Annexure F

Peer review reports

F.1 Flood model peer review (BMT 2022 and BMT 2023)

RE: FLOOD MODELLING PEER REVIEW

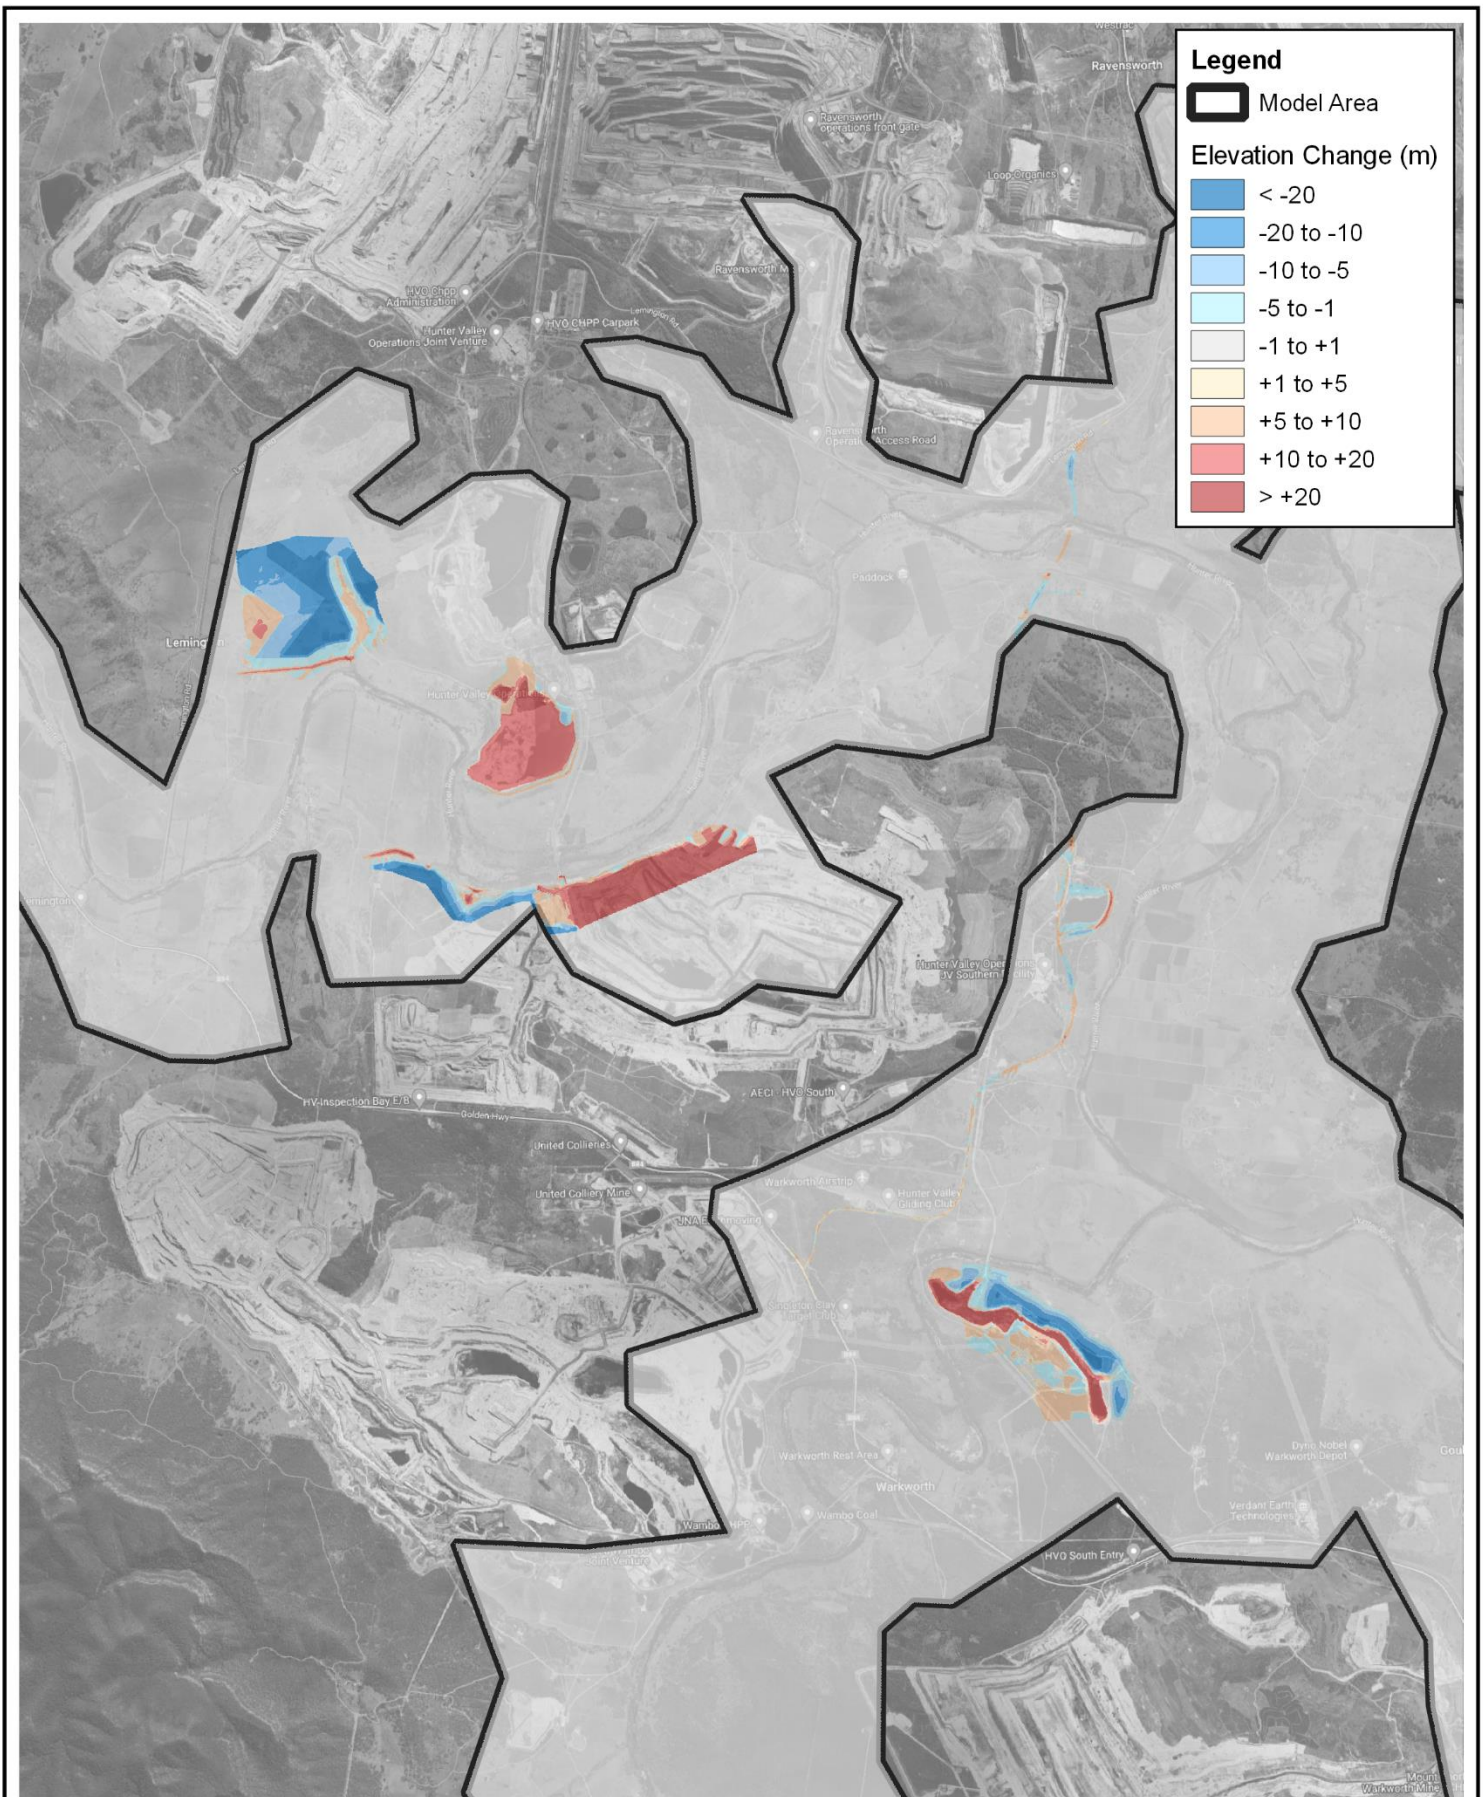
Figure 1 presents the difference in model topography from existing to design conditions. The DEM modifications appear to appropriately represent the scale and nature of the proposed works. However, it is noted that the adopted model grid resolution of 8m may not explicitly define the contiguous crest levels of narrow linear features such as levees and road embankment where they are read into the model directly via a DEM surface (1 or 2m resolution) and have not been reinforced by other 2d_shape layers.
